STAFF RECOMMENDATION

1404 Linden Avenue

May 16, 2018

Application: New construction – infill

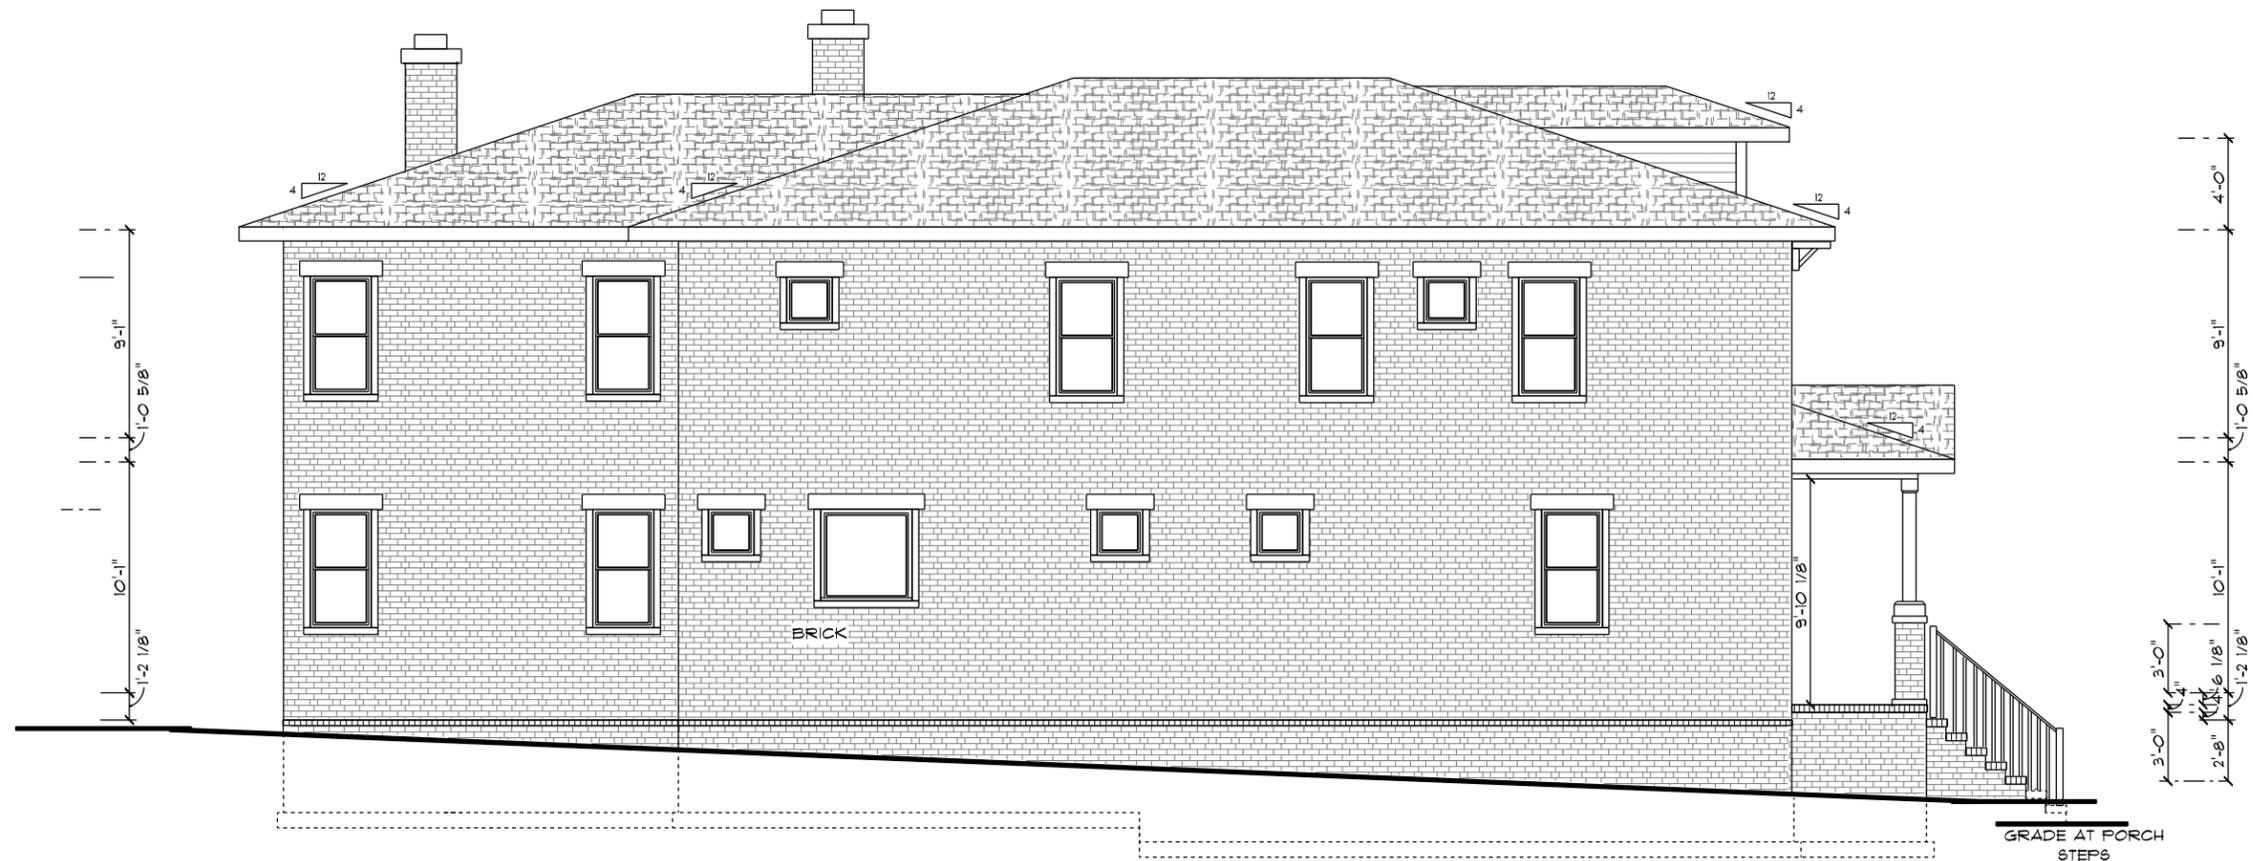
Height & Scale: The new building will be two stories, with a maximum height of approximately thirty-two feet, five inches (32'5") from grade at front. The site slopes up towards the back, so the foundation height at the front needs to be tall; it is proposed to be between four and six feet (4'-6') tall at the front. Staff recommends that the applicant work with staff during construction to ensure that the foundation and finished floor heights are compatible with those of the historic houses on either side of it. The eave height will be approximately twenty feet (20') tall above the foundation line.

*The drawings show that there will not be a change in material from the foundation to the wall above. Both materials are shown as brick. Staff recommends that there be a change in material from the foundation to the wall above. If the primary cladding material remains as brick, then

possible foundation materials could be stone, split face concrete block, or stucco. Not only do historic homes typically have a foundation material that is different than the primary cladding material, a change in material will help to mitigate the tall foundation at the front of the home.

15. The front porch be a minimum of six feet (6') deep;
16. A change in material occur between the foundation and the wall above;
17. The front steps and porch floor be wood or concrete;

ROOF PLAN
 SCALE: 1/8" = 1'-0"

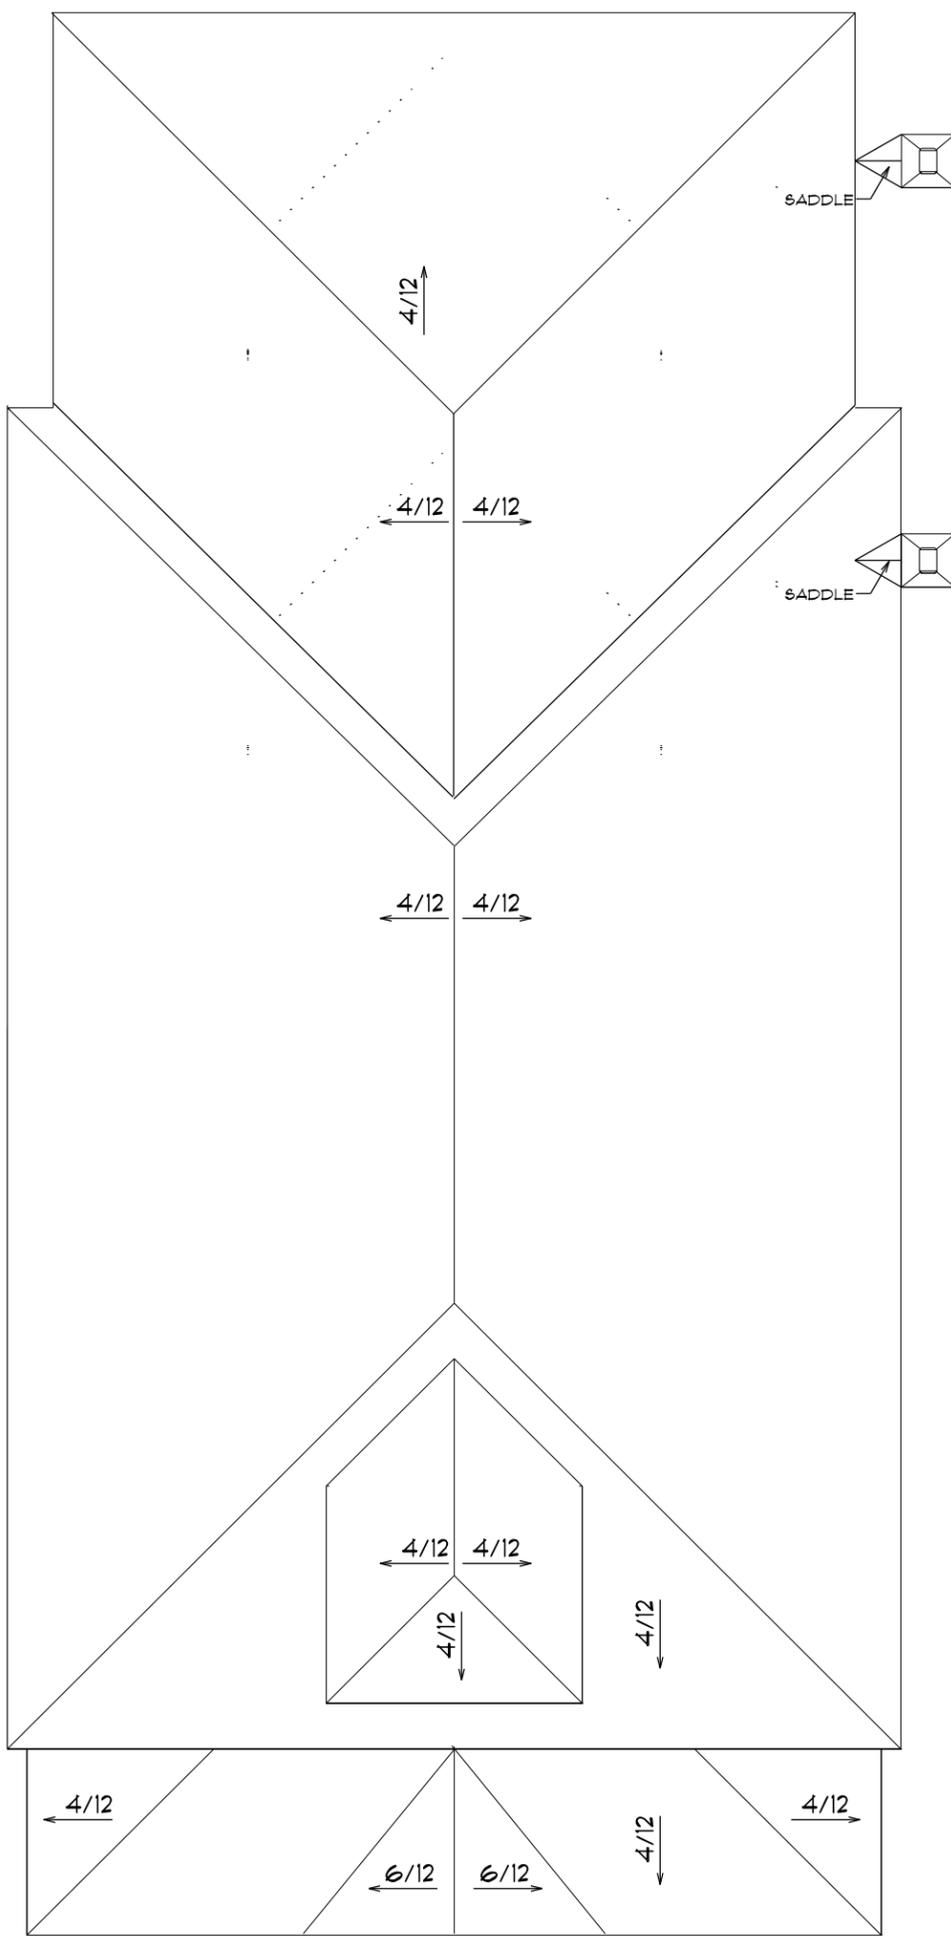
Roof form: The roof will be hipped with a 4/12 slope. The design guidelines state that roof slopes should generally be a minimum of 6/12. Staff finds the proposed roof form and slope to be appropriate in this instance because hipped roofs often had lower slopes than other historic roof forms. MHZC has approved two-story hipped roofs in the past that had slopes of 4/12. In addition, the lower roof slope helps to keep the height of the infill compatible with the historic context.

The hipped front dormer also has a roof slope of 4/12. The dormer is inset two feet (2') from the wall below and is appropriately scaled. Staff finds that the proposed roof forms meet Section II.B.1.e of the design guidelines.
